UNITED STATES PATENT AND TRADEMARK OFFICE

APPLICATION NO.	FILING DATE	FIRST NAMED INVENTOR	ATTORNEY DOCKET NO.	CONFIRMATION NO.
09/914,874	09/05/2001	Johann Michael Koehler	F-7129	6041

Office Action Summary	Application No. 09/914,874	Applicant(s) KOEHLER, JOHANN MICHAEL	
	Examiner Jyoti Nagpaul	Art Unit 1743

DETAILED ACTION

Figure 1. Jiang Microfluidic Device

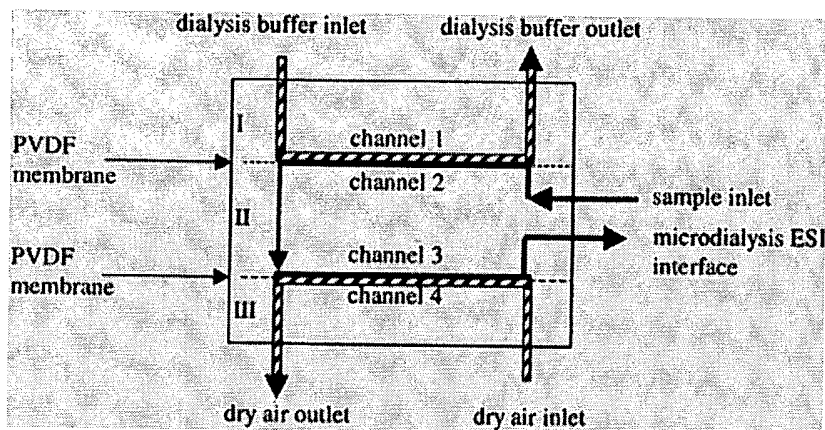
Jiang discloses a microfluidic device that includes a first substrate (I, see Figure 1) and a second substrate (III) wafer being engaged to one another in a common plane,

where a longitudinally extending channel (see figure 3) is inserted into one substrate wafer, The channel is captured by two passage openings (see Figure 1 or 3), which are passed through the substrate wafer. Filter elements (PVDF membrane, see Figure 1 or 3) are provided, and the passage openings are separated from the channel by a partially permeable sieve-like membrane. The membrane has transmission areas (see Figure 3) so that they prevent micro-beads and/or cells, which are introduced into the channel, from entering into the passage openings. The channel is provided with two further openings outside (see Figure 3) of the section captured by passage openings. The two openings is adapted to enable a loading and/or a displacement of the micro-beads and/or cells, provided above the section captured by a passage, by applying a fluidic pressure and further comprising means for temporarily closing at least one of the passage openings and one of the further openings. (Also refer to Figure below) Jiang discloses plurality of substrate wafers that include two passage openings each and linearly fluidically interconnected by channels. A recitation of the intended use of the claimed invention must result in a structural difference between the claimed invention and the prior art in order to patentably distinguish the claimed invention from the prior art. If the prior art structure is capable of performing the intended use, then it meets the claim. In a claim drawn to a process of making, the intended use must result in a manipulative difference as compared to the prior art. See *In re Casey*, 152 USPQ 235 (CCPA 1967) and *In re Otto*, 136 USPQ 458, 459 (CCPA 1963).
